BID PACKAGE 02 – ADDENDUM 01**Date:** January 10, 2020**Re:** Wilma P Mankiller Health Center Expansion**From:** James R Childers Architect, Inc.
45 South 4th Street
Fort Smith, Arkansas 72901

CHANGE NARRATIVE LETTER

TO: MATHEW THOMAS- CHILDERS ARCHITECTS
FROM: STEPHEN EDMONDSON, TREY SMITH, BETSY WELLS– HP ENGINEERING, INC.
DATE: 1/10/2020
PROJECT: WPMHC EXPANSION BID PACKAGE 02 ADDENDUM 01

E2.10
CENTER SECTOR 2 ENLARGED LIGHTING PLAN

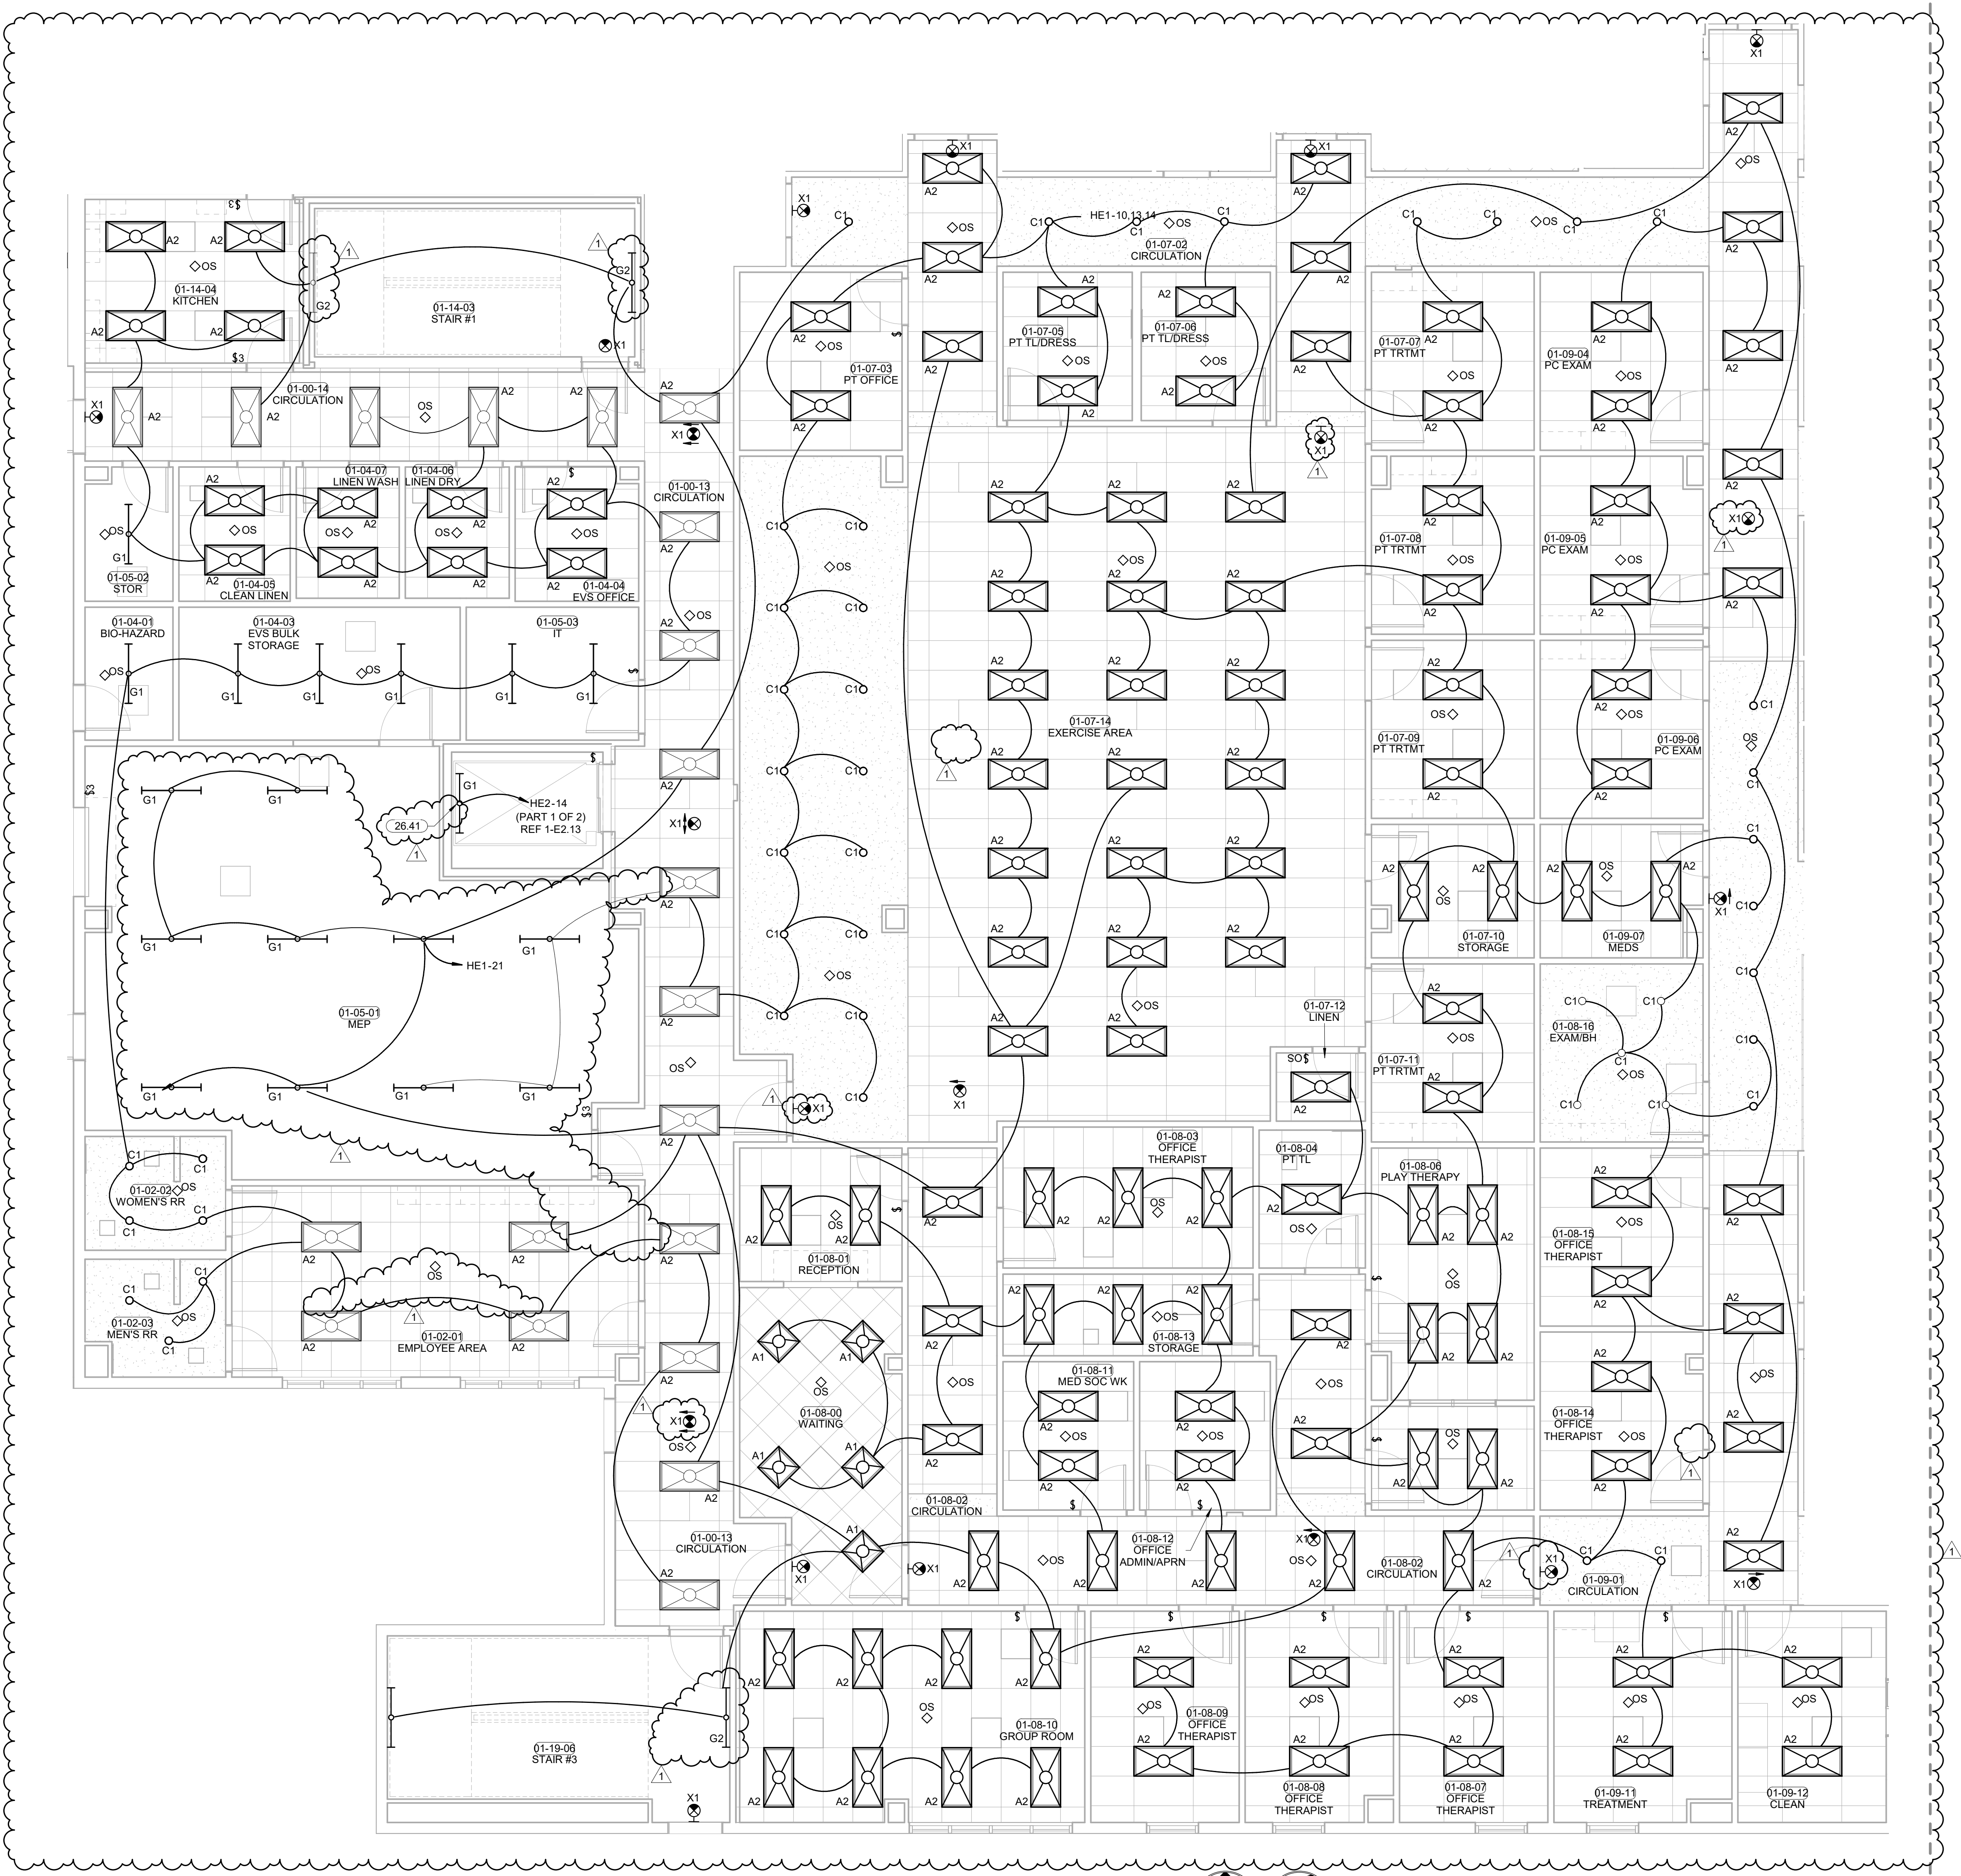
- k. Detail 1 – Revised location of (2) Type C1 fixtures in Women’s RR 01-00-03.
30. E2.10
- a. Detail 1 - Revised (1) Type G1 fixture to be Type G2 in Stair #3 01-19-06.

- b. Detail 1 – Removed (1) ceiling OS from Stair #3 01-19-06.
 - c. Detail 1 – Revised (1) Type X1 fixture two be dual faced in Circulation 01-00-13.
 - d. Detail 1 – Removed (1) ceiling OS from Employee Area 01-02-01.

- e. Detail 1 - Revised location of (1) ceiling OS in Employee Area 01-02-01.
 - f. Detail 1 - Revised circuitry for light fixtures in MEP 01-05-01.
 - g. Detail 1 - Added keynote 26.41 to elevator Type G1 fixture.

- h. Detail 1 – Added (2) Type X1 fixtures to Exercise Area 01-07-14.
 - i. Detail 1 – Removed (1) Type X1 fixture from Exercise Area 01-07-14.
 - j. Detail 1 – Added (1) Type X1 fixture to Circulation 01-09-01.

- k. Detail 1 – Removed switch from Office Therapist 01-08-14.
 - l. Detail 1 – Added (1) Type X1 fixture to Circulation 01-07-02.
 - m. Detail 1 – Revised (2) Type G1 fixtures to be Type G2 in Stair #1 01-14-03.

SHEET NUMBER:
E2.11
 NORTH SECTOR
 1 LEVEL 02
 ENLARGED
 LIGHTING PLAN

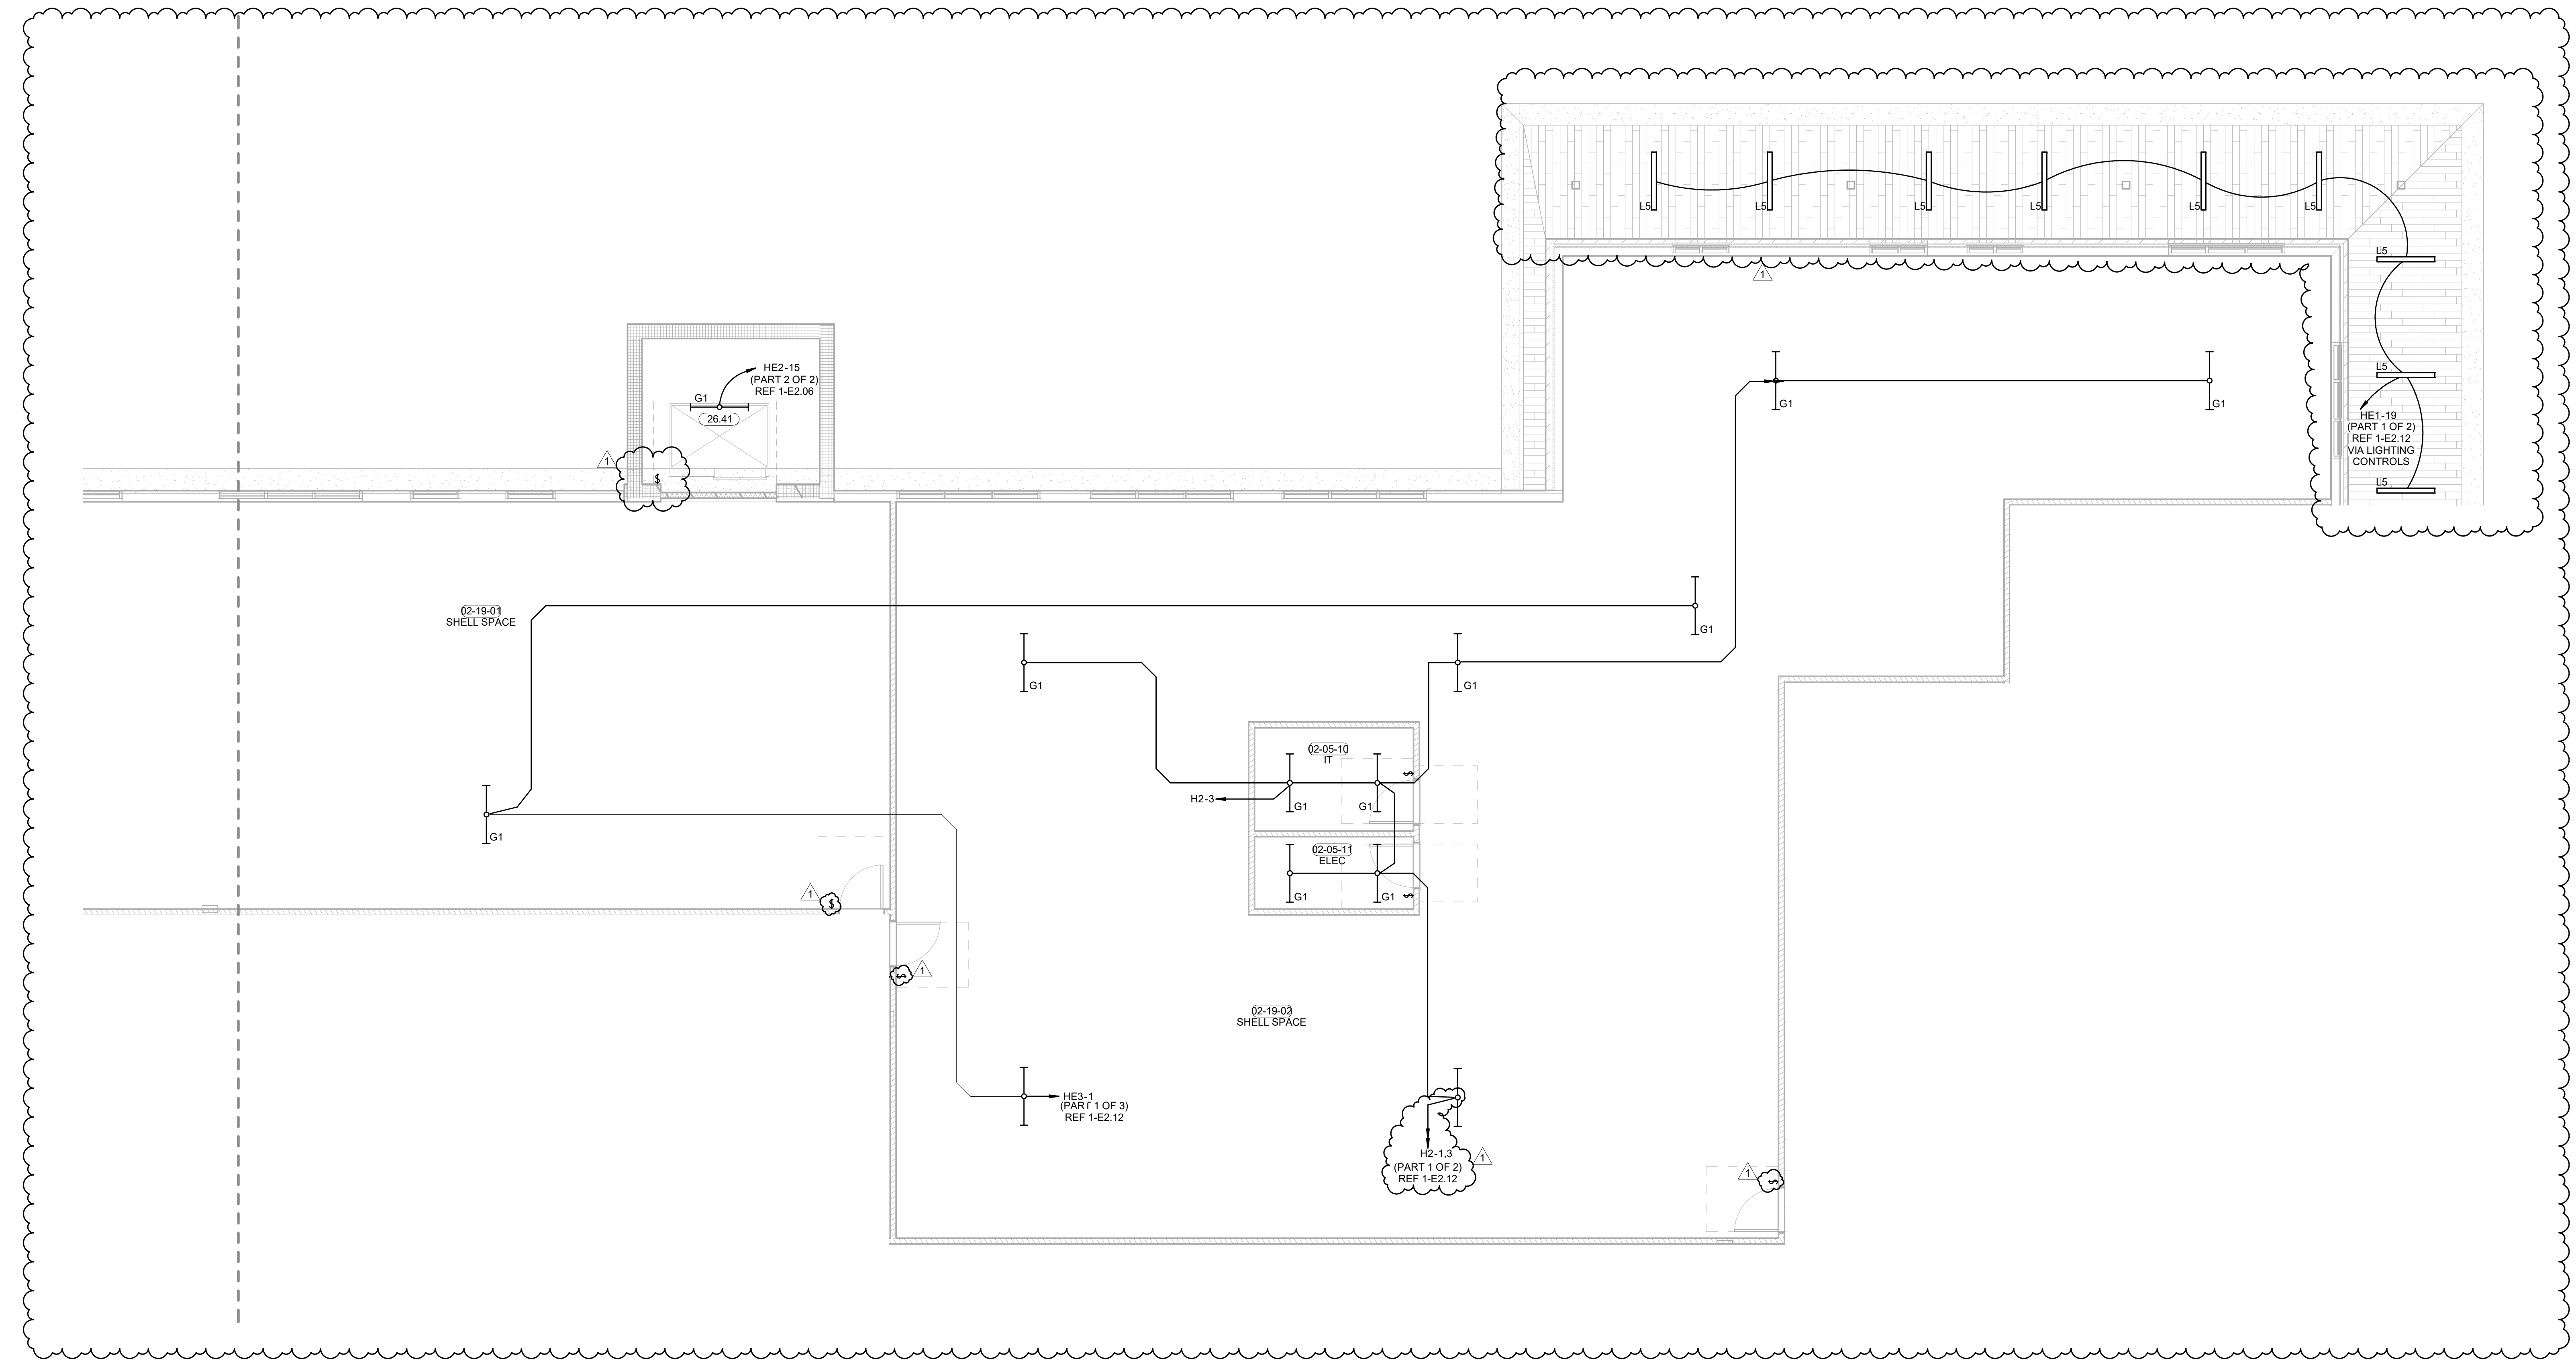
31. E2.11
- a. Detail 1 – Added circuitry note for circuit HE3-1.
 - b. Detail 1 – Added (1) switch to Shell Space 02-19-01.
 - c. Detail 1 – Added (2) switches to Shell Space 02-19-02.
